IOWA ELECTRIC LIGHT AND POWER COMPANY

August 30, 1977
IE-77-1624

PROPOSED CHANGE RTS-95 TO DAEC TECHNICAL SPECIFICATIONS

POSITION 1: Second Level of Under-or-Over Voltage Protection with a Time Delay

FIGURE 1 - DAEC ESSENTIAL ELECTRICAL SYSTEM

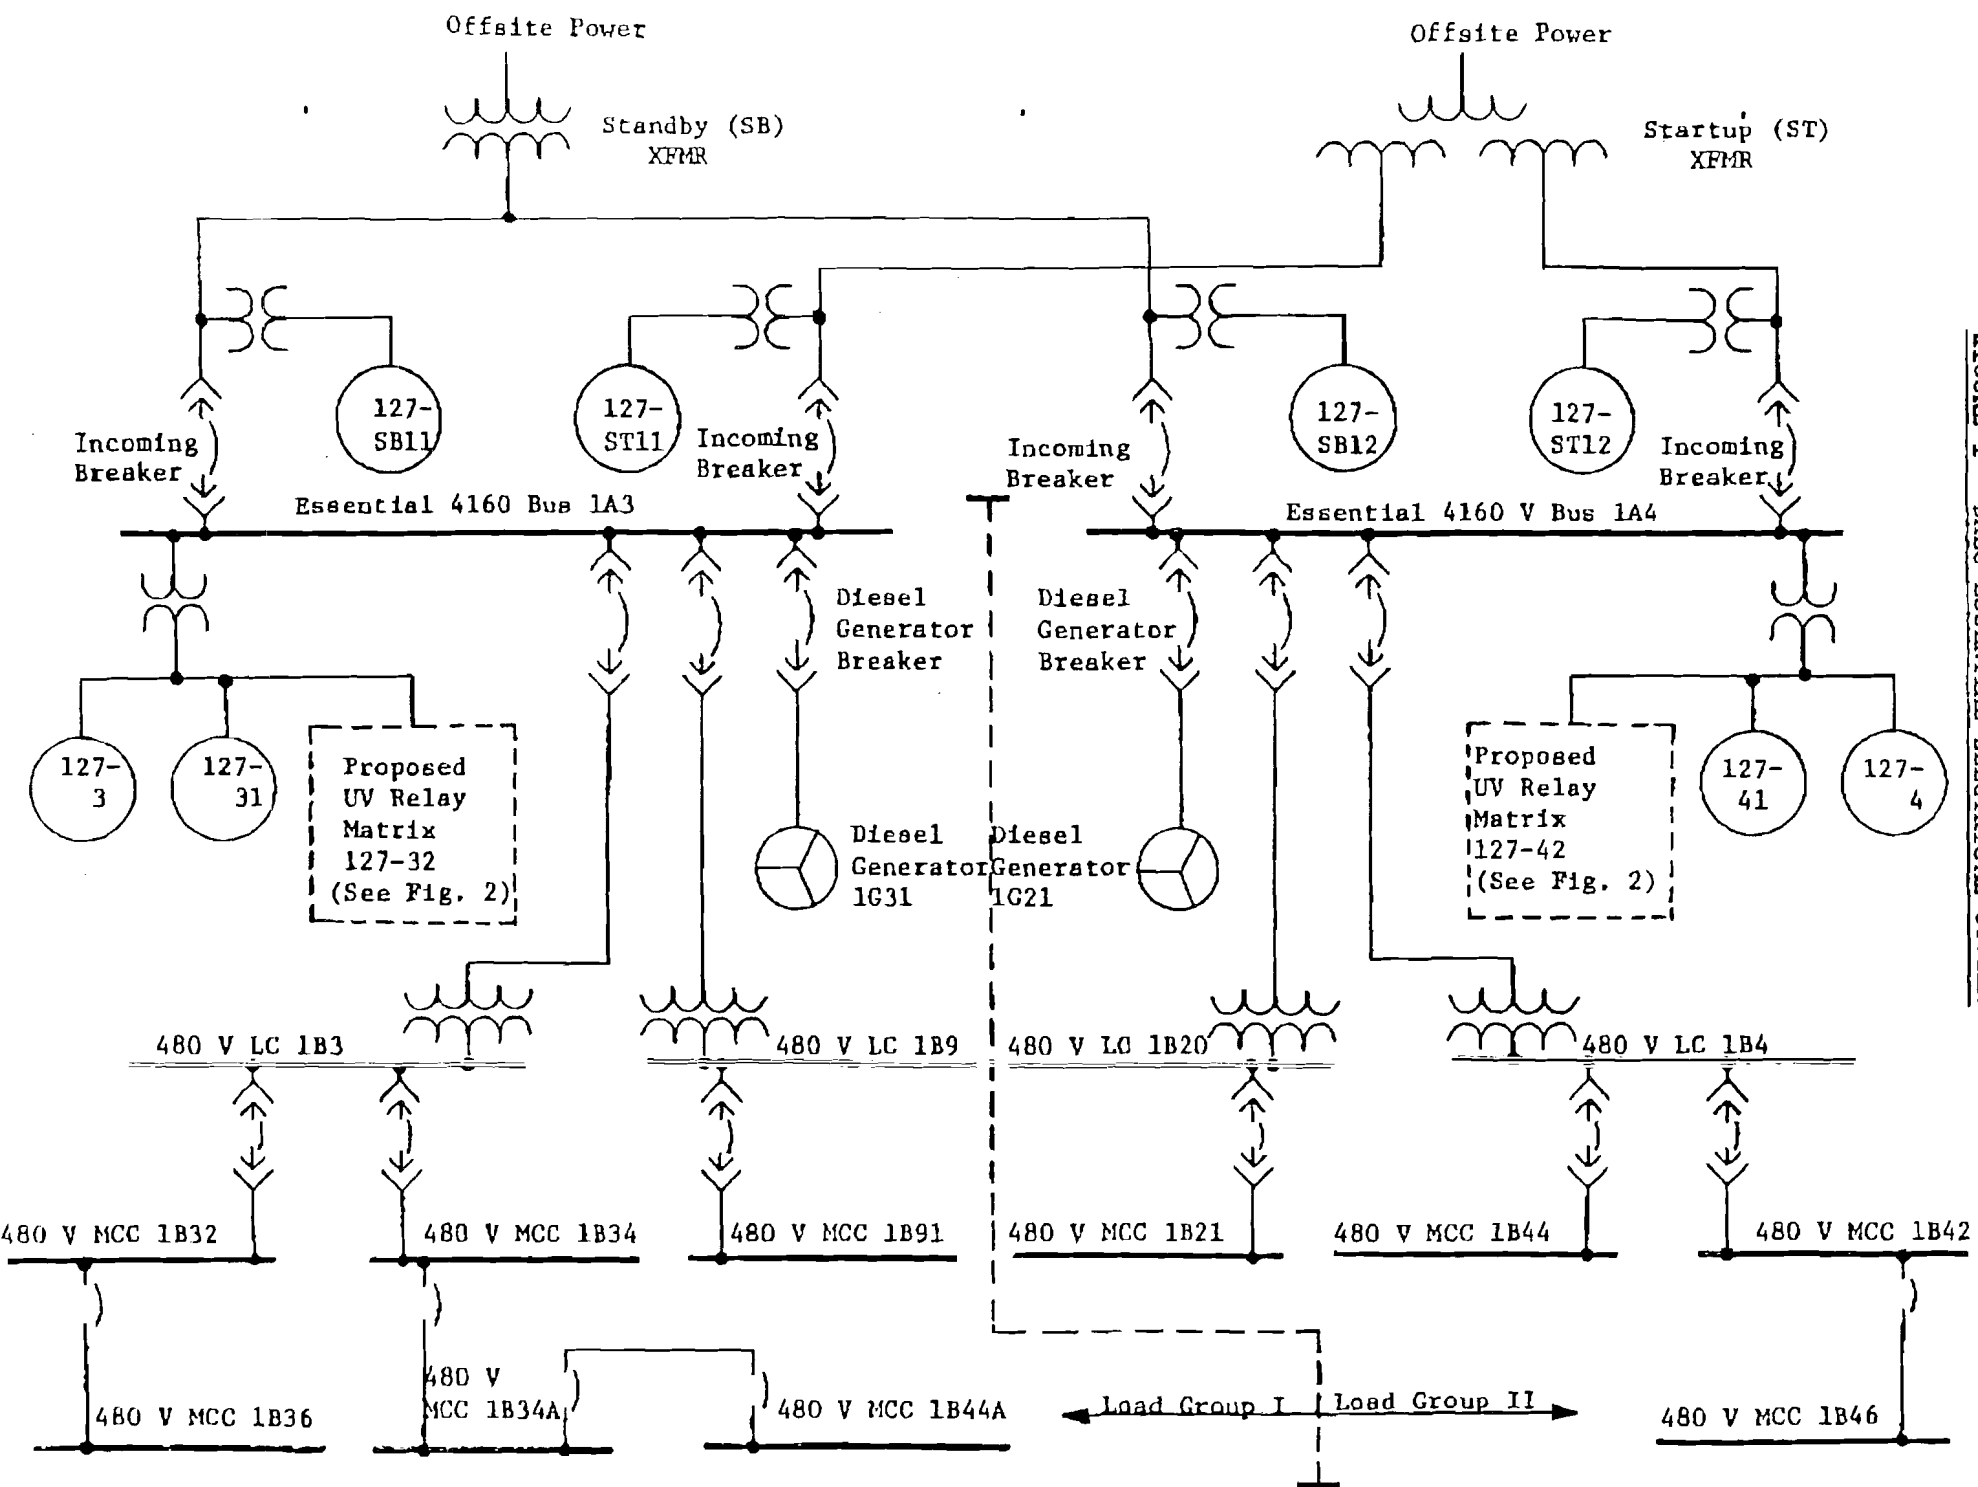
According to the voltage profile tables sent with our response of October 19, 1976 to your generic questions of August 11, 1976, essential motor control centers 1B36 and 1B46 consistently maintain the lowest voltage levels and may be considered the worst case. The voltage calculations made to prepare our previous response show that 86 percent of nominal voltage at MCC's 1B36 and 1B46 corresponds to a voltage level of 92.2 percent at 4.16 kV essential buses 1A3 and 1A4. We propose to establish the second level of undervoltage protection at 92.2 percent of nominal voltage on buses 1A3 and 1A4 by installing four additional single phase undervoltage relays to each of the essential 4.16 kV buses. Refer to Figure 1.

FIGURE 2 - UNDERVOLTAGE RELAY COINCIDENCE LOGIC

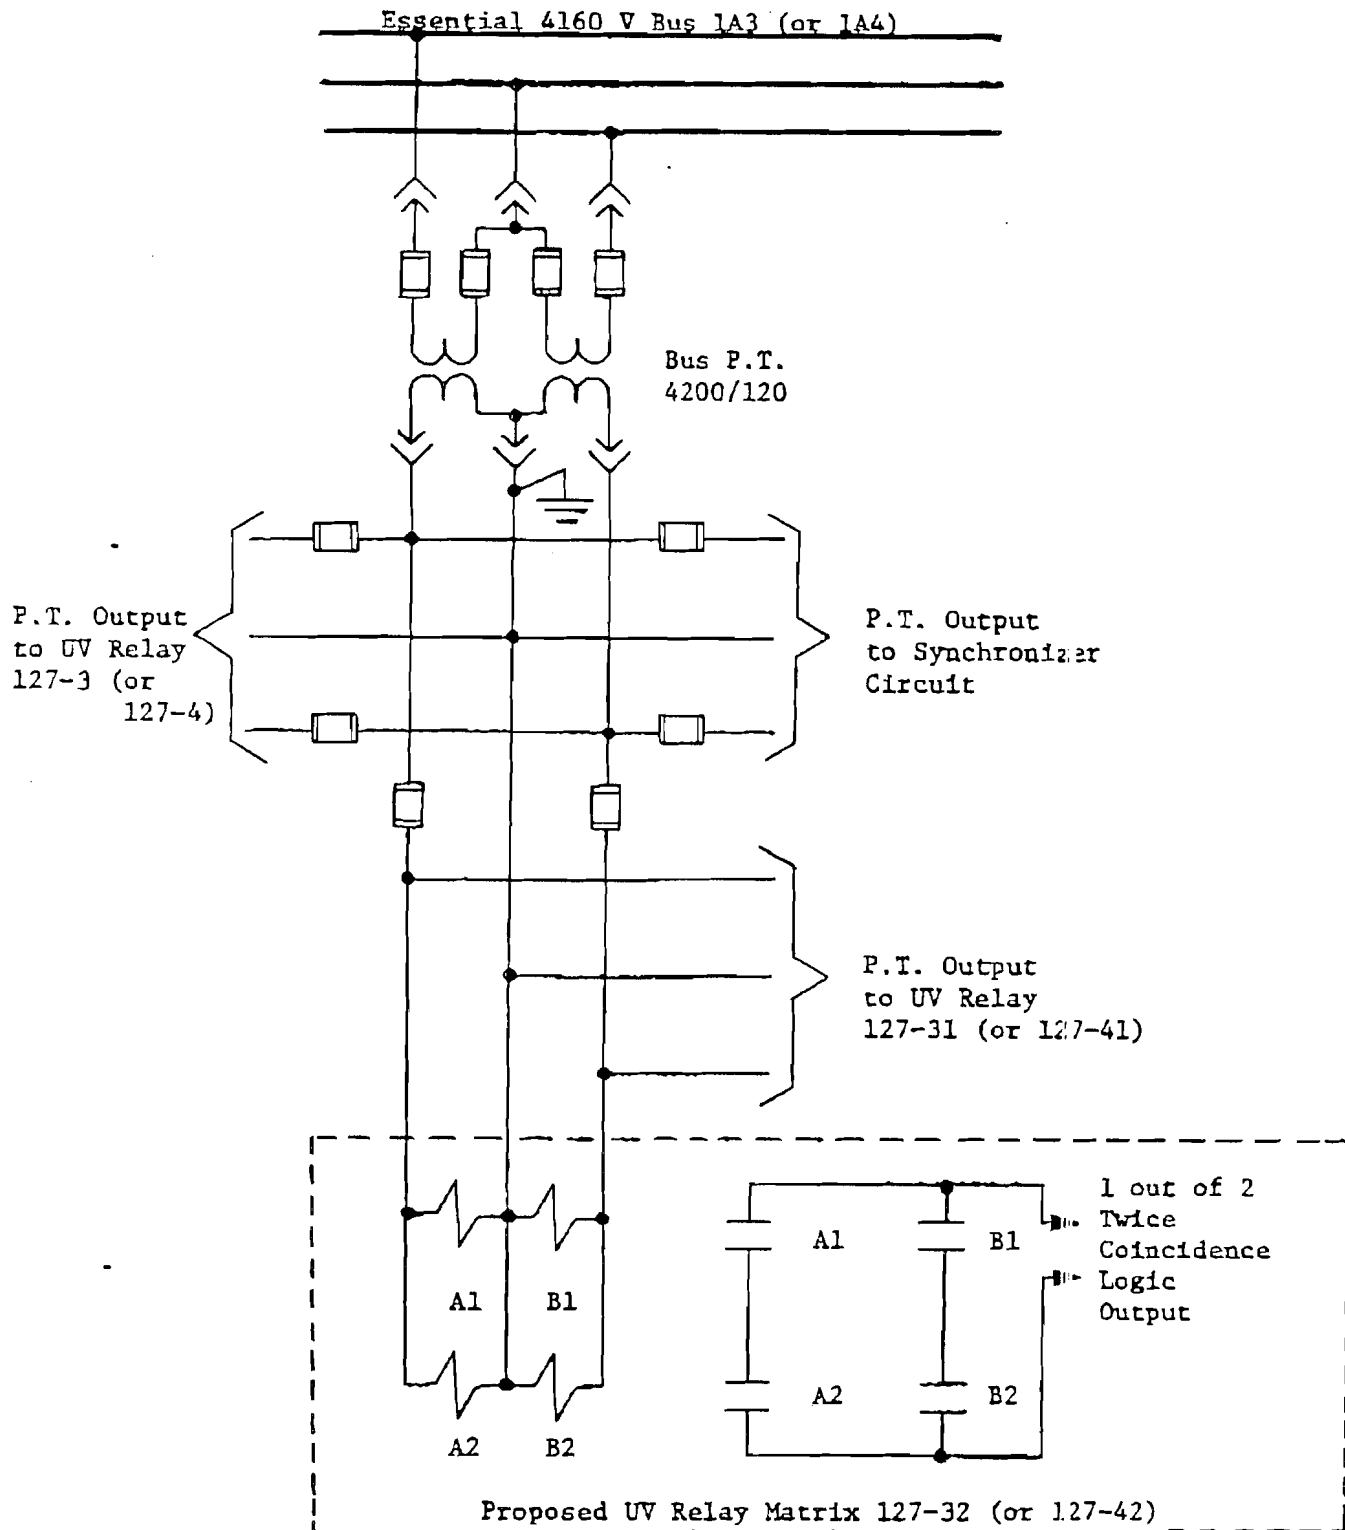
The output contacts of the four undervoltage relays on each bus will be connected in series parallel to form a one-out-of-two-twice coincidence logic matrix. Refer to Figure 2. The one-out-of-two-twice coincidence logic is already used in the Reactor Protection System. The coincidence logic precludes a single blown Potential Transformer (P.T.) fuse or malfunctioning relay from either preventing a safety action when it is required or causing a spurious trip of an offsite power source. The coincidence logic permits relay testing and calibration during power operation. The coincidence logic is fail safe.

1. The proposed relays are instantaneous undervoltage relays with integral timers. The relay output contacts open if the monitored voltage drops below the voltage setpoint for the length of the time delay. The logic is fail safe.
2. The bus and relay numbers listed first are for Load Group I. The numbers in parentheses are for Load Group II.
